MAGNOLIA HOTEL

UDPRP

JUNE 18, 2025

SYCAMORE DEVELOPMENT | GENSLER

MAIN ENTRANCE & COMMERCE STREET FACADE

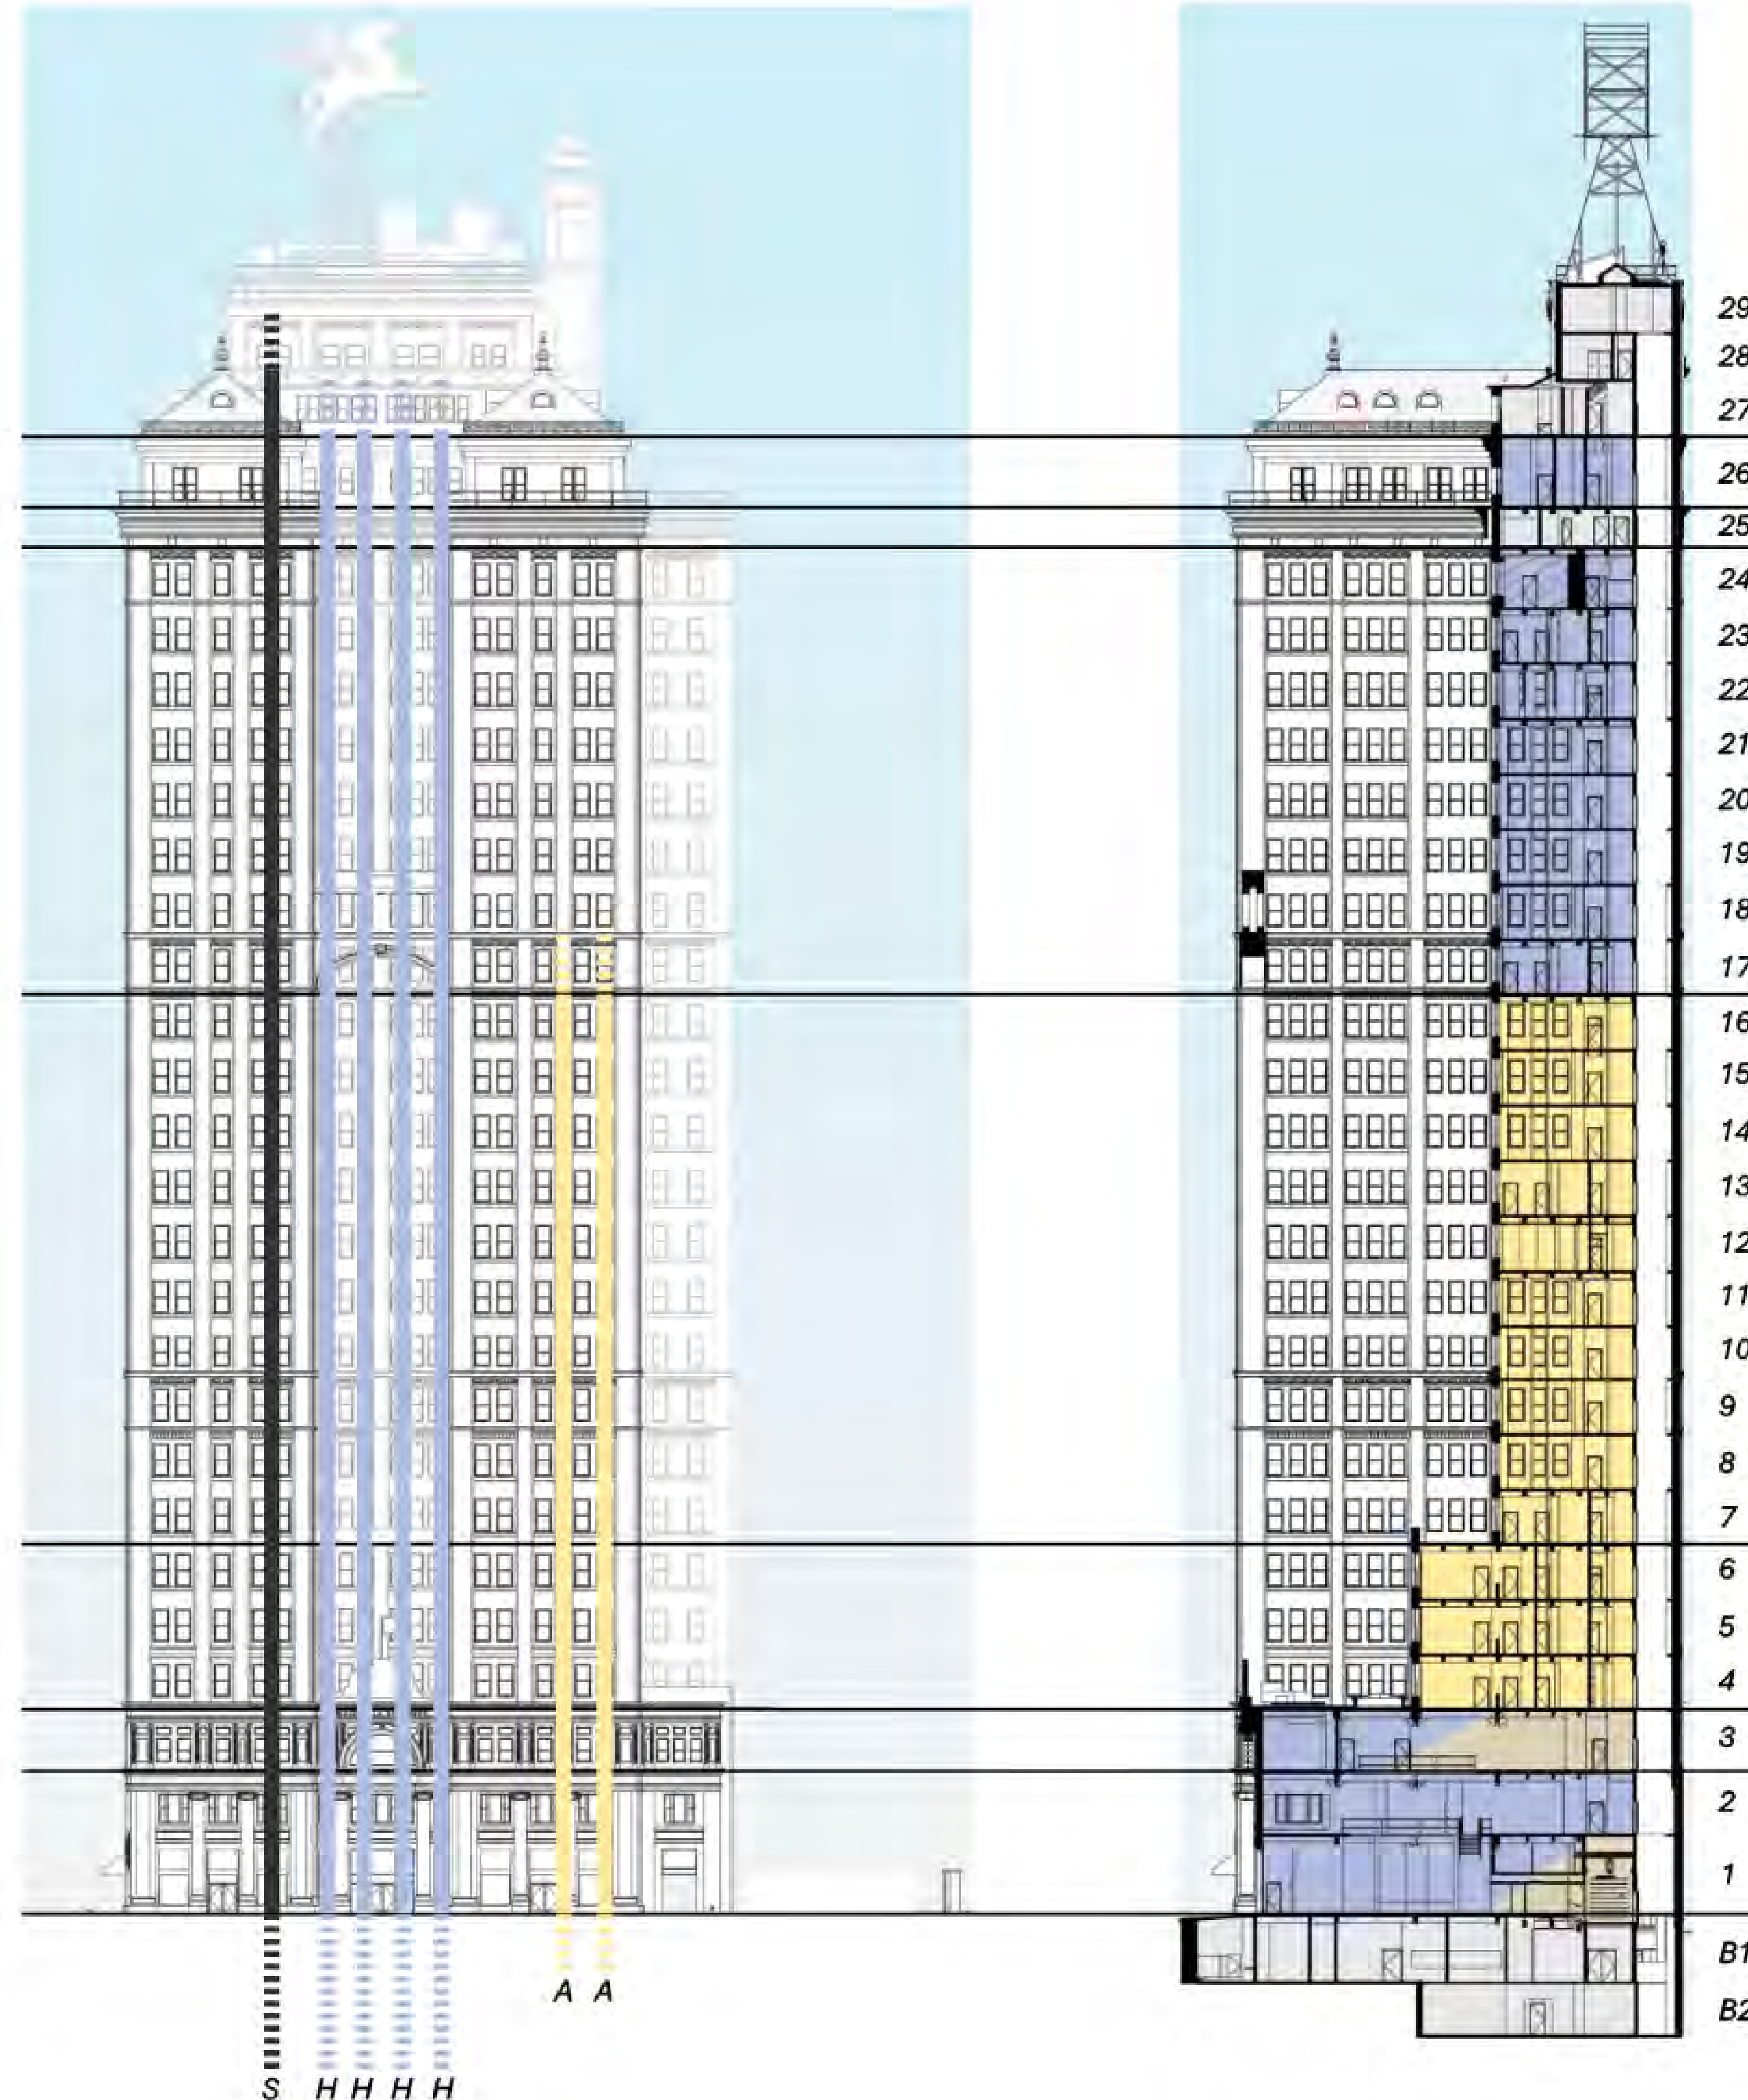
- [1] Careful consideration should be given on treatment of the vehicular drop off area, entry, and facade to ensure prioritization of pedestrian experience and safety along Commerce Street.
